LAKEHAVEN WATERAND SEWER DISTRICT

2026 REDONDO PRIMARY AND SECONDARY CLARIFIERS REHABILITATION

ADDENDUM NO. 4

Issued: October 21, 2026

STRUCTURAL PRIMARY CLARIFIERS SUGGESTED ROOF REMOVAL PLAN

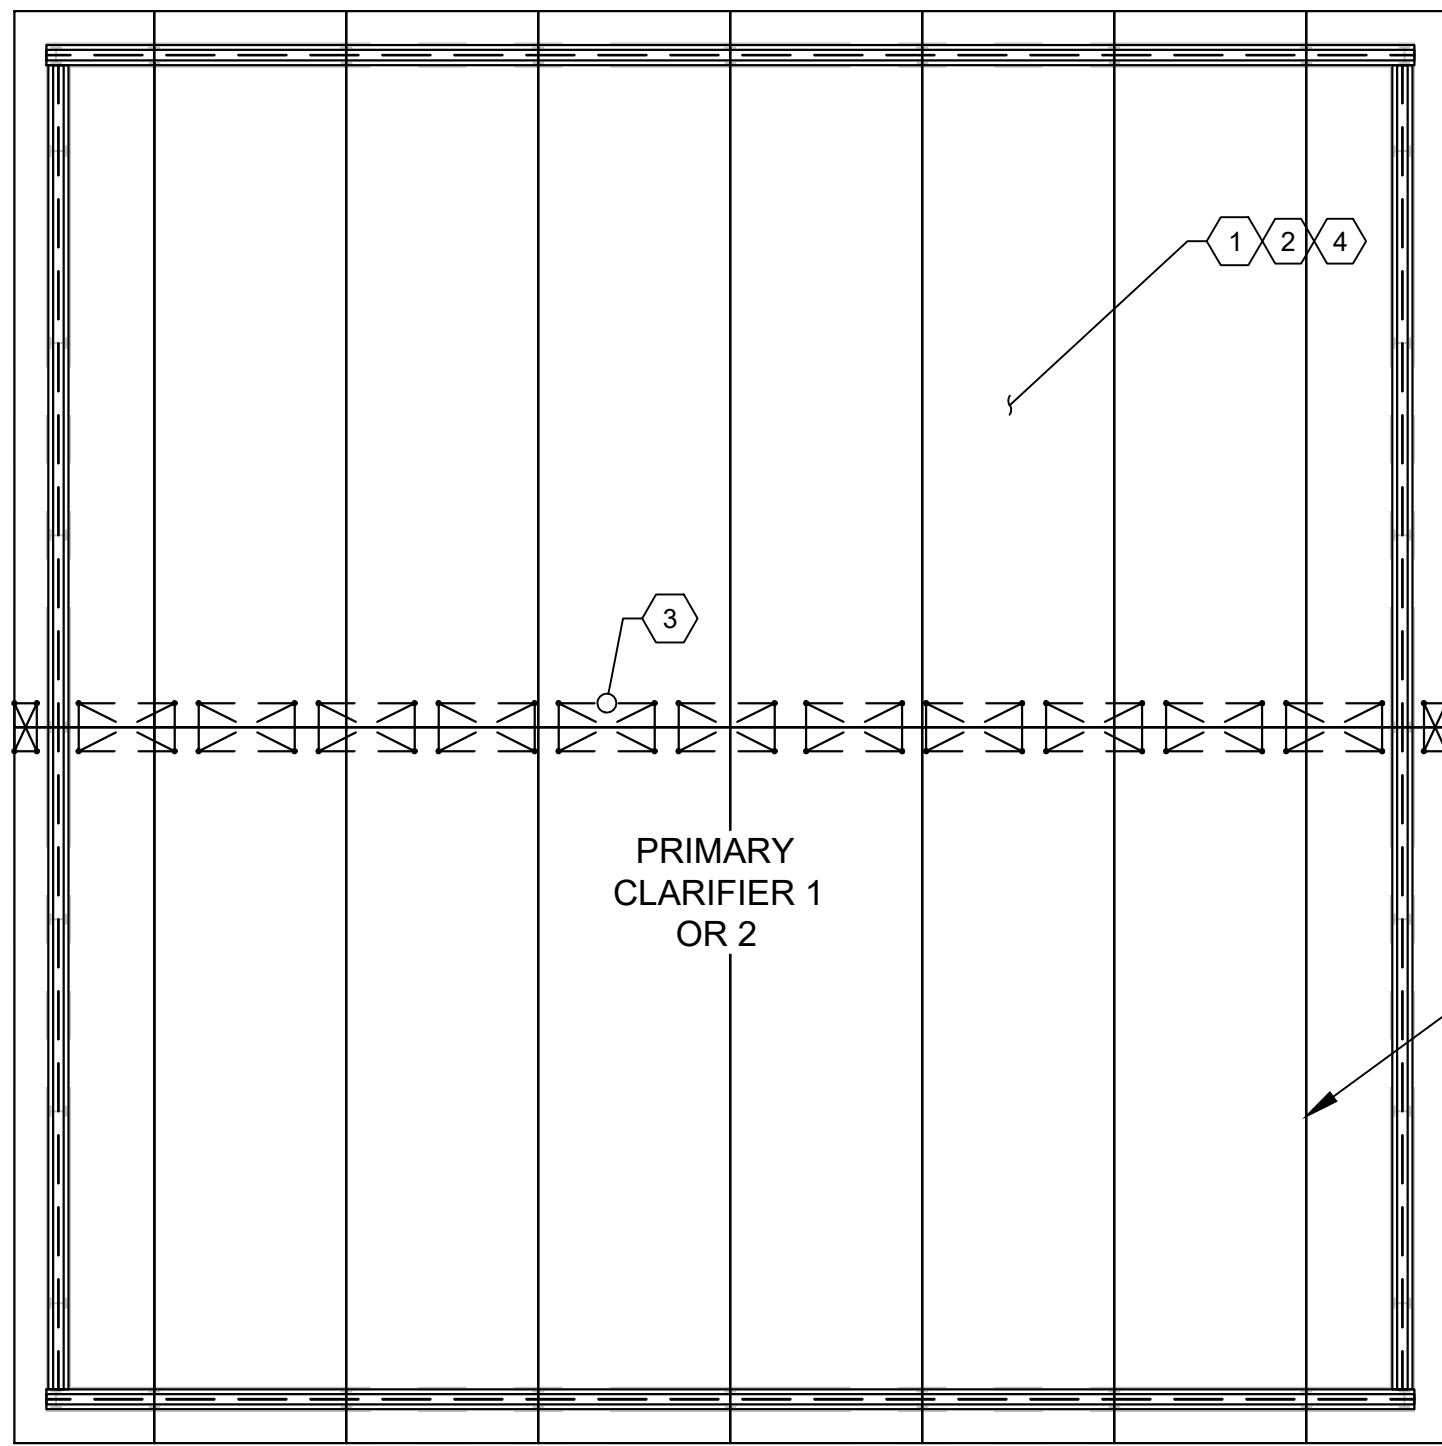
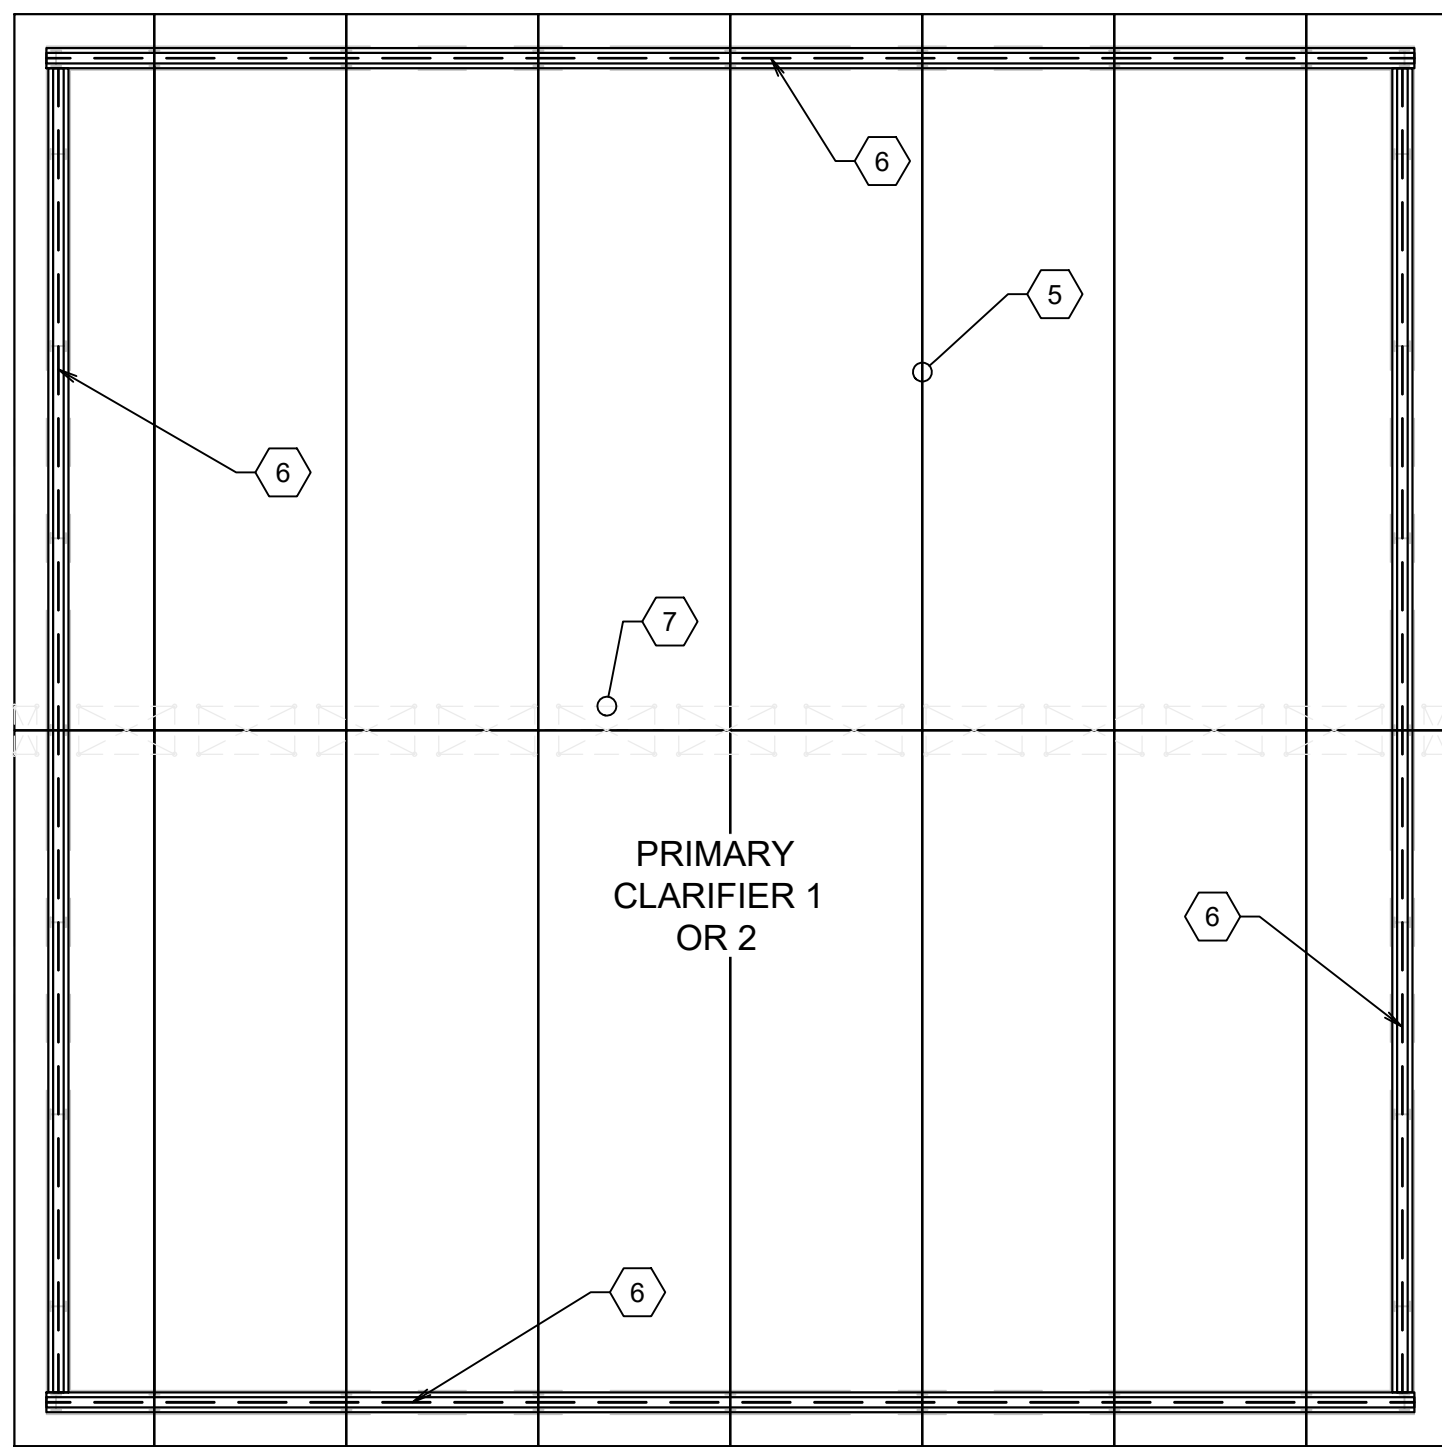
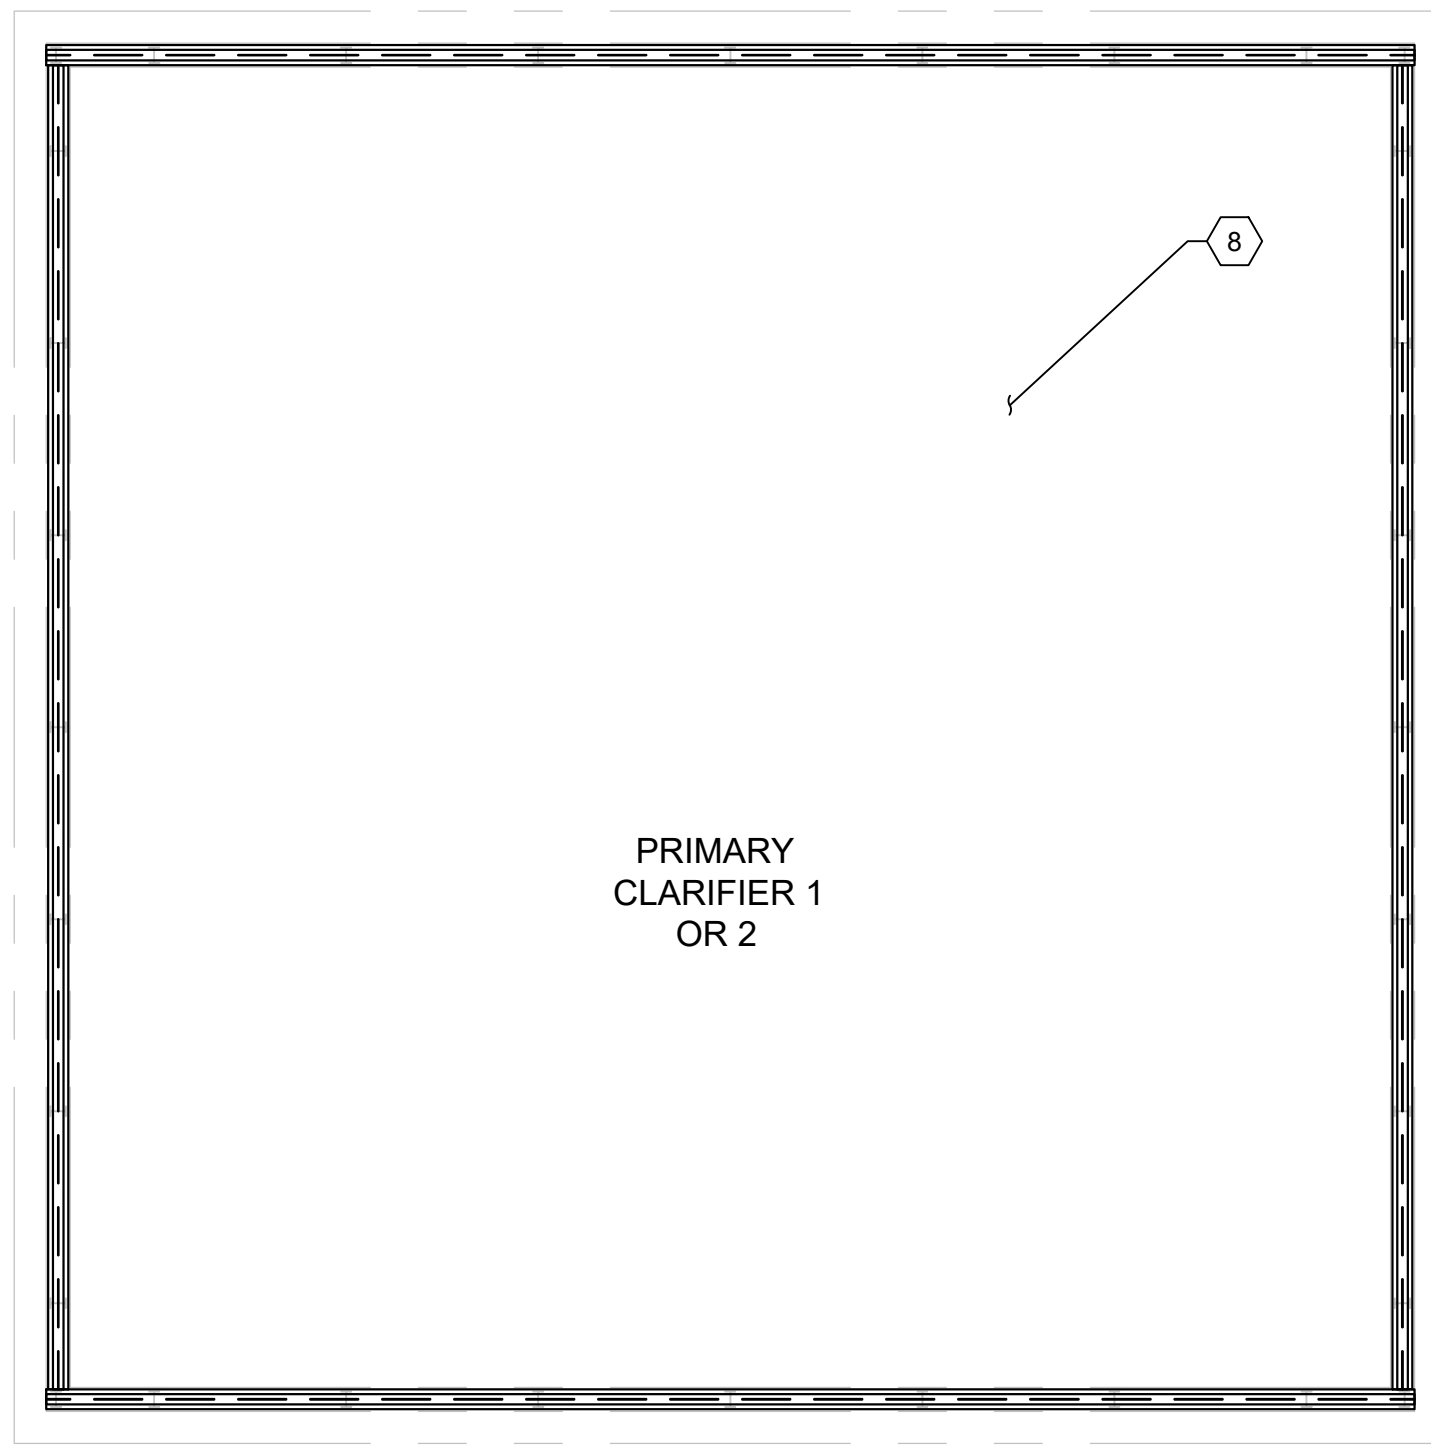
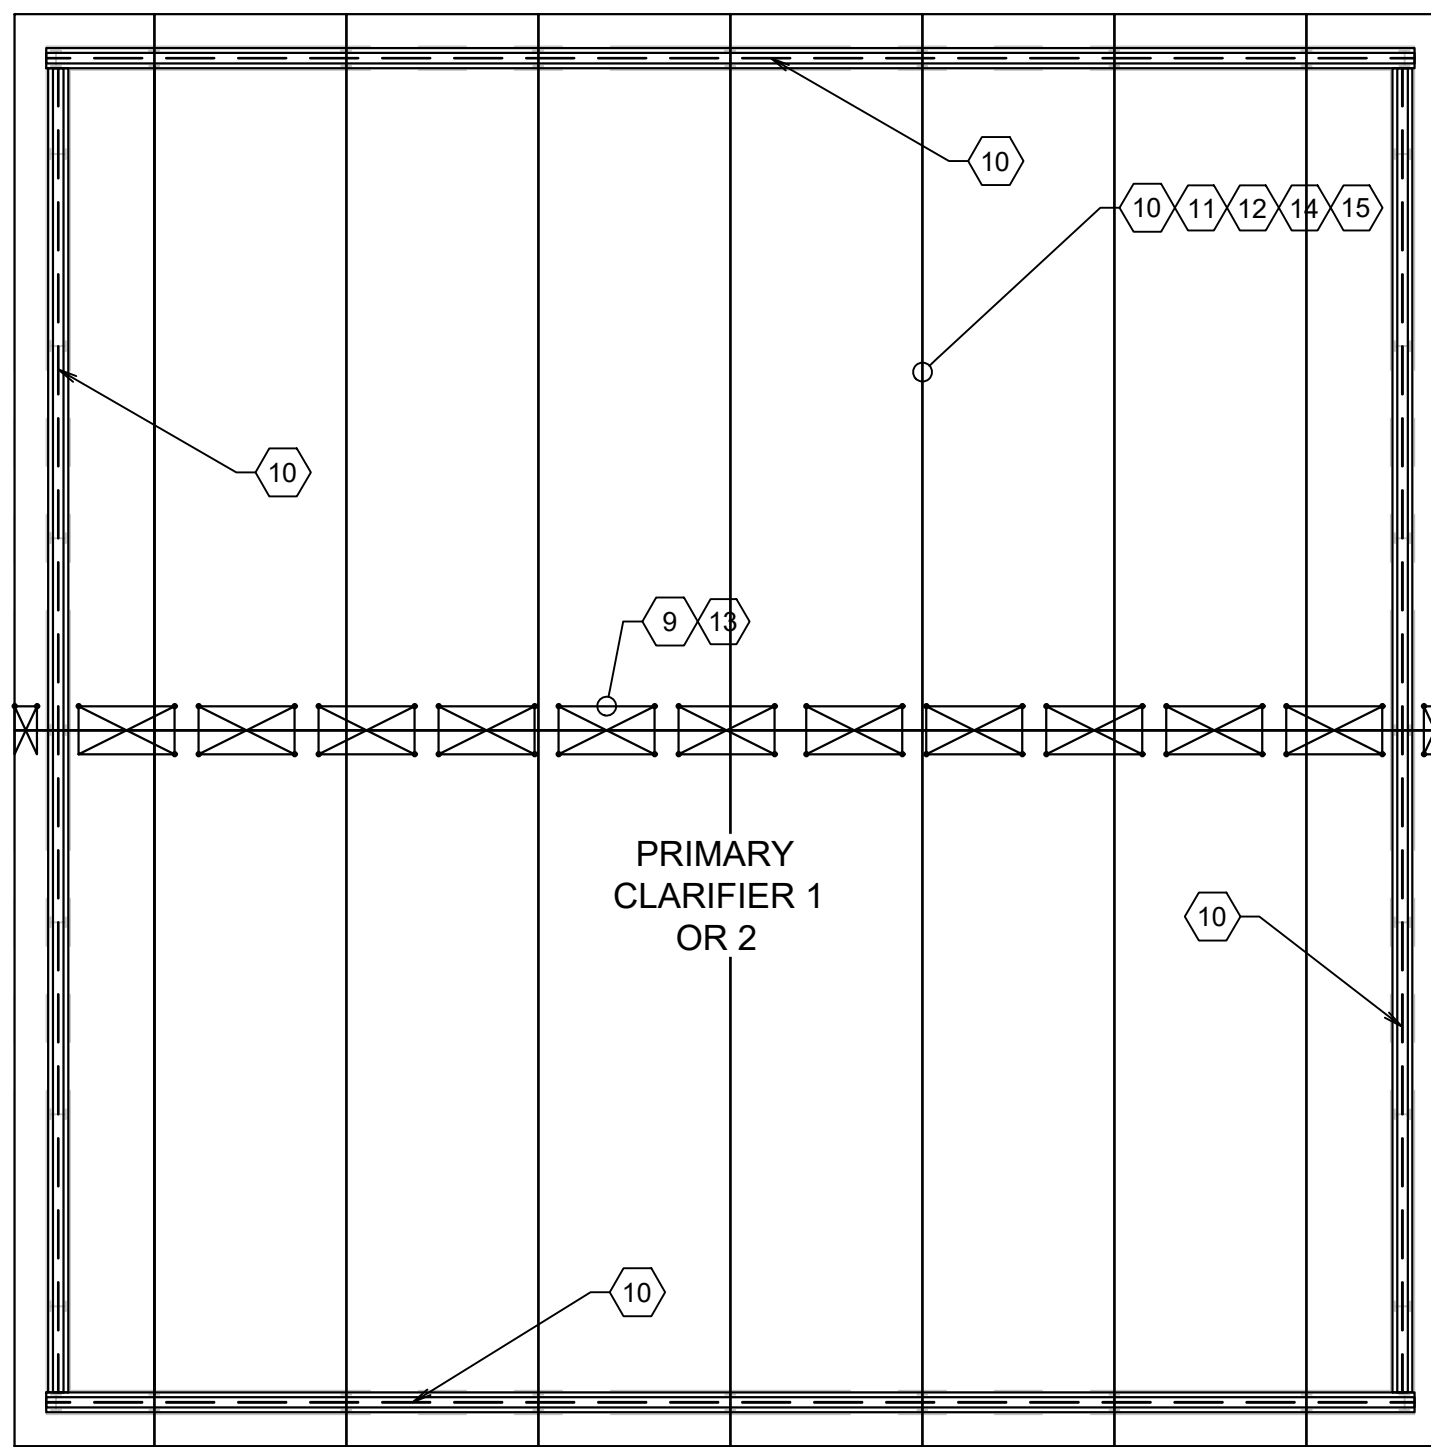
“8. ROOF PANELS ARE NESTED, INTERLOCKED, AND BOLTED TOGETHER AND TO THE ROOF BEAMS FOR SUPPORT. SEQUENTIAL REMOVAL, IN THE DIRECTION OF THE NESTING, AND TEMPORARY SUPPORT ARE REQUIRED DURING ROOF PANEL REMOVAL AND REINSTALLATION. REFER TO SPECIFICATION SECTION 01 50 00 AND SECTION 02 41 00 3.02.B. FOR MORE INFORMATION. REFER TO DRAWING A-01 FOR ADDITIONAL INFORMATION RELATED TO THE SUGGESTED ROOF REMOVAL AND REINSTALLATION SEQUENCING.”

“3. ROOF PANELS ARE NESTED, INTERLOCKED, AND BOLTED TOGETHER AND TO THE ROOF BEAMS FOR SUPPORT. SEQUENTIAL REMOVAL, IN THE DIRECTION OF NESTING, AND TEMPORARY SUPPORT ARE REQUIRED DURING ROOF PANEL REMOVAL AND REINSTALLATION. REFER TO SPECIFICATION SECTION 01 50 00 AND SECTION 02 41 00 3.02.B. FOR MORE INFORMATION. REFER TO DRAWINGS A-02 AND A-03 FOR ADDITIONAL INFORMATION RELATED TO THE SUGGESTED ROOF REMOVAL AND REINSTALLATION SEQUENCING.”
